**Pacific Gas and  
Electric Company**

July 30, 2004

PG&E Letter DCL-04-089

Docket No. 50-275, OL-DPR-80  
Docket No. 50-323, OL-DPR-82  
Diablo Canyon Units 1 and 2  
Response to June 14 and July 6, 2004, NRC Request for Additional Information  
Regarding License Amendment Request 03-18, "Revision to Technical  
Specifications 5.5.9, 'Steam Generator (SG) Tube Surveillance Program,' and  
5.6.10, 'Steam Generator (SG) Tube Inspection Report,' for 4-volt Alternate Repair  
Criteria for Steam Generator Tube Repair"

FIGURE 1

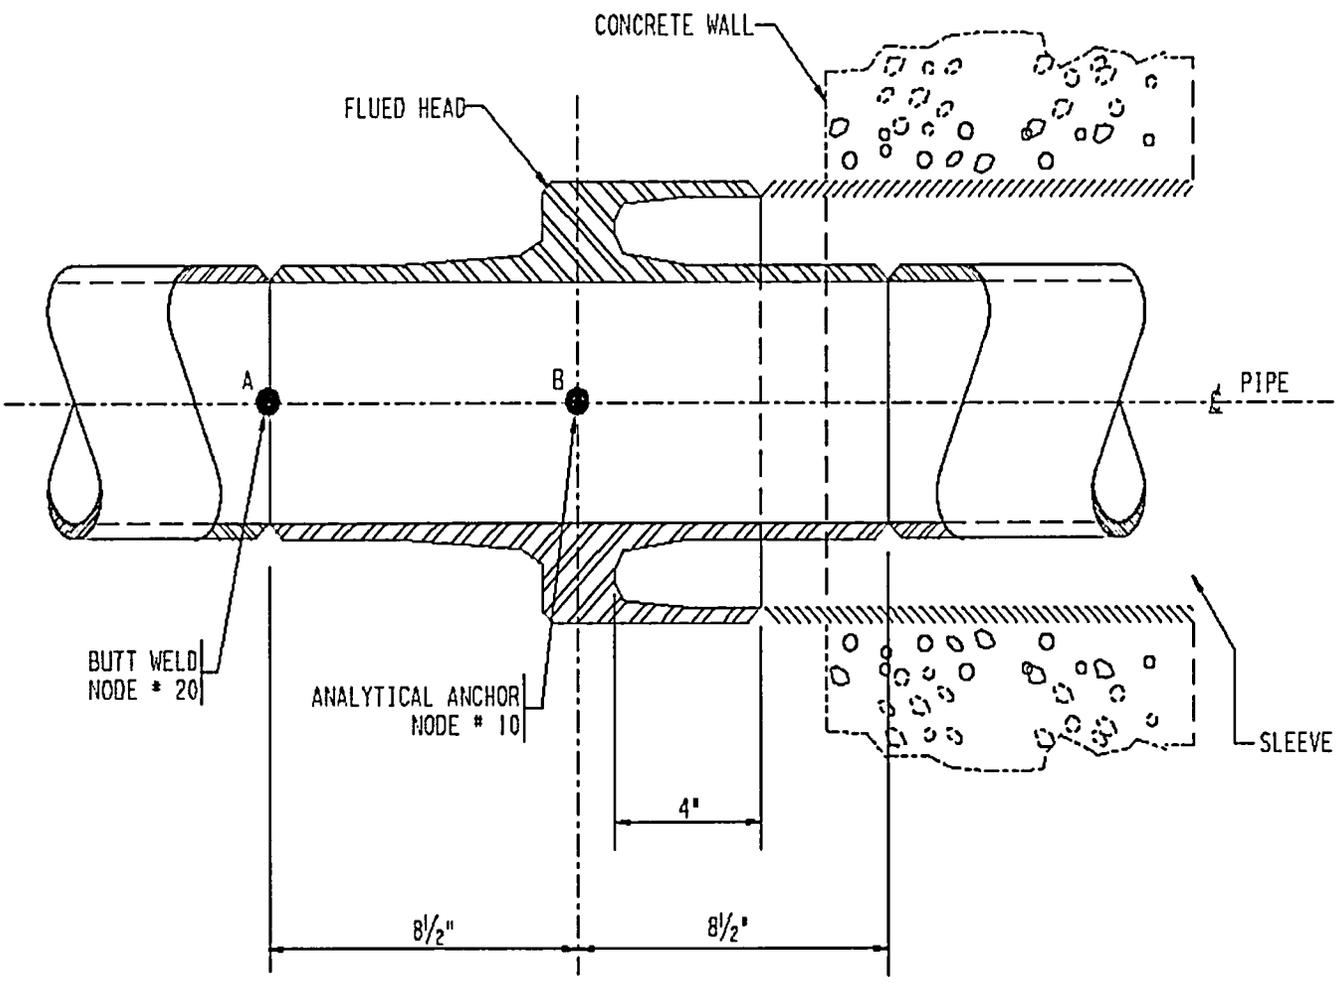
*Page 6-5. Last sentence. It is stated that the total NOP (normal operating) + SSE moment at location 10 of steam generator 1-2 is 9441 in-kips. However, location 10 and 9441 in-kips are not shown in Table 4-6, which lists all nodes and applied moments for the main steam line associated with steam generator 1-2. (a) Explain why location 10 is not included in Table 4-6 and whether the applied moment in node 10 was included in the critical crack size and leakage crack size calculations. (b) It seems that the type and magnitude of applied dynamic moments for node 10 and node 20 should be similar because node 10 is close to node 20. However, the data show that the applied moment at node 20 is dominated by the MSIV actuation loads not SSE loads whereas the applied moment at node 10 is dominated by the SSE load. Discuss the applied moments for node 10 and node 20.*

Node point 10 (and node point 130 in the Unit 2 analyses) was not included in the critical crack size and leakage calculations. The reason is that node point 10 is not a weld location, and is not even a point on the pipe – it is part of the containment penetration flued head, as shown in Figure 1. The flued head has a much larger outside diameter and is much thicker than the connecting main steam pipe. The larger cross section of the flued head indicates that any potential pipe break would preferentially occur in the main steam pipe and not in the flued head. Node point 20 is the location of the weld between the flued head and the main steam pipe, and is the last weld point on the pipe before the increased diameter of the flued head. Review of the applied moment data indicates that the moments at node points 10 and 20 are similar. Whether the MSIV or SSE loads govern varies by DCP unit, line, and location. However, for each of the main steam lines, when the MSIV load governs at node point 10, it also governs at node point 20. On main steam lines 1-1, 1-2, and 1-4, the MSIV load governs at both node points 10 and 20. On main steam line 1-3, the SSE load governs at both points 10 and 20.
